Subject: Proposed Modification to the Davis-Besse Nuclear Power Station Operating License NPF-3, Appendix A Technical Specification (TS) 3/4.4.5, Steam Generators, to Modify Single Repair Roll Requirements and Allow the Use of the Double Repair Roll Process for Steam Generator Tubes Within the Upper Tubesheet (LAR No. 99-0001; TAC No. MA7829)

**SAFETY ASSESSMENT AND SIGNIFICANT HAZARDS CONSIDERATION
FOR
LICENSE AMENDMENT REQUEST NO. 99-0001**

Proposed Modification to the Davis-Besse Nuclear Power Station (DBNPS) Operating License NPF-3, Appendix A Technical Specification (TS) 3/4.4.5, Steam Generators, to Modify Single Repair Roll Requirements and Allow the Use of the Double Repair Roll Process for Steam Generator Tubes With Defects Within the Upper Tubesheet

Figure
Tube Repair Rolls

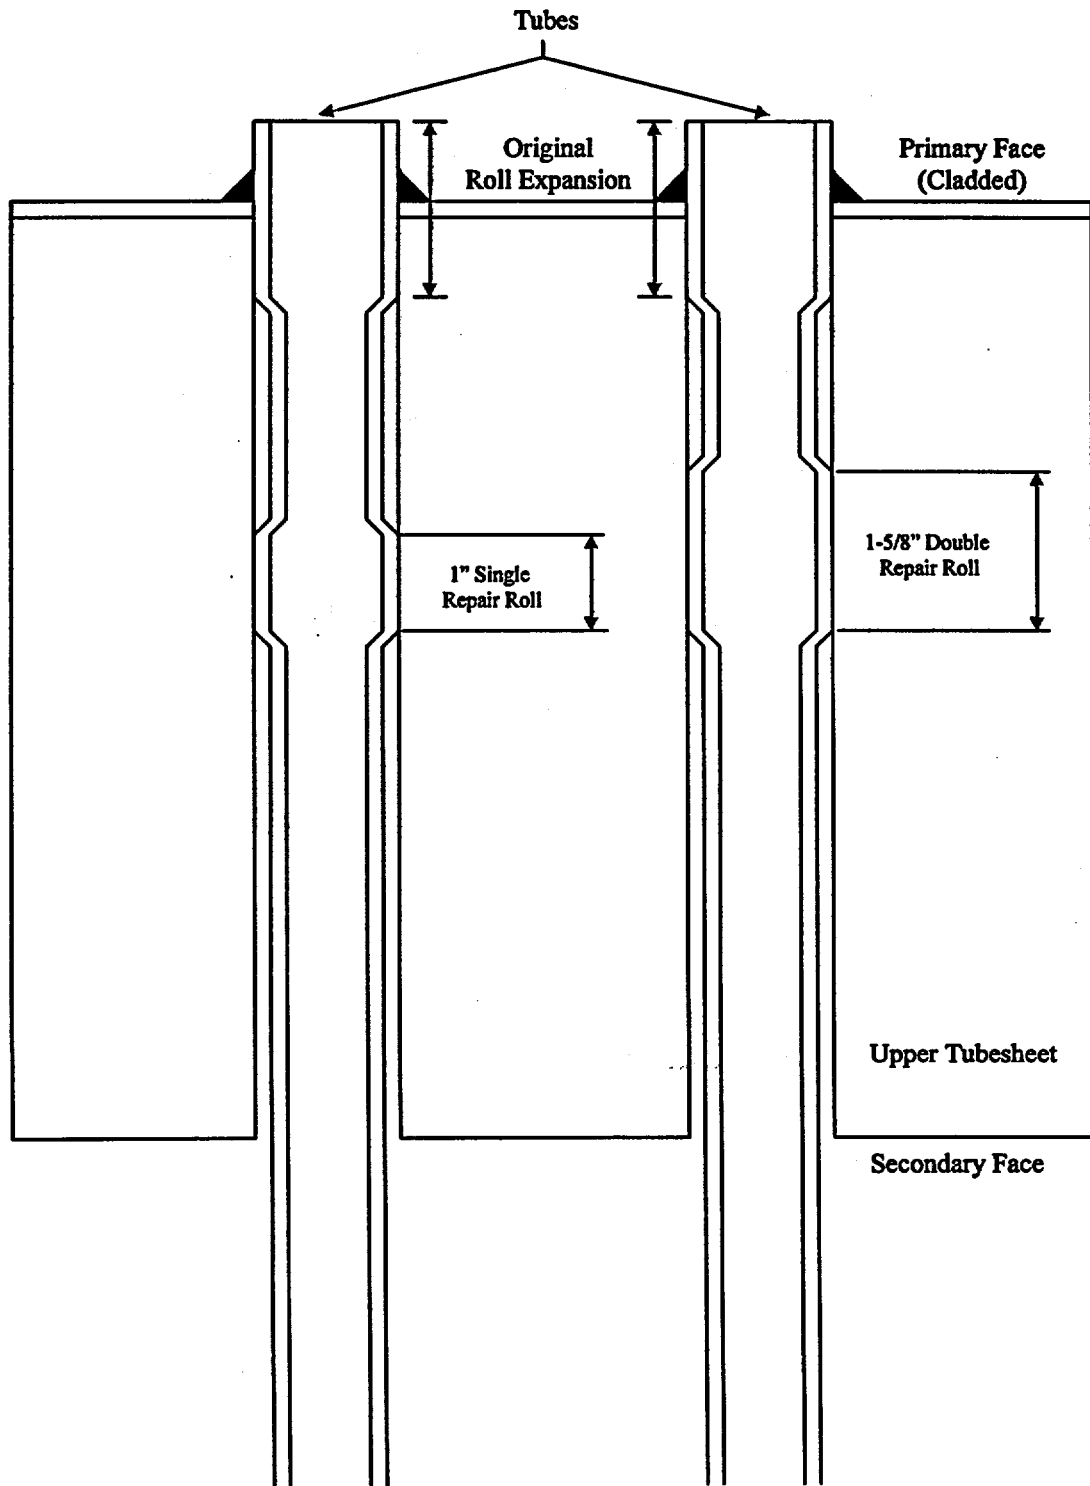
The proposed revision would also eliminate the restriction on only using a single roll and permit the use of two overlapping 1-inch tube roll expansions to produce a 1-5/8 inches long repair roll ("double roll"). The double repair roll provides a tube-to-tubesheet joint that is stronger than the single repair roll. The proposed revision would require the double repair roll process be performed in accordance with Topical Reports BAW-2303P, Revision 3, as supplemented by Topical Report BAW-10236P, Revision 0. Topical Report BAW-10236P also defines steam generator tube exclusion zones where application of the single or double repair rolls is prohibited, based upon the tensile load on the tubes. A location is excluded if the repair roll load carrying capability is predicted to be less than 110% of the limiting transient tube load. Technical Specification Bases 3/4.4.5 is also proposed for revision to make it consistent with the proposed revised SR 4.4.5.4.a.7.

The repair roll method being modified in this LAR provides a method of repair for steam generator tubes that have sustained degradation of the tube within the steam generator upper tubesheet. The repair roll is a process whereby a new primary to secondary pressure boundary joint is established by hard rerolling the tube closer to the secondary face of the tubesheet. The new pressure boundary joint is established to remove the area of degradation from pressure boundary service (see the attached figure).
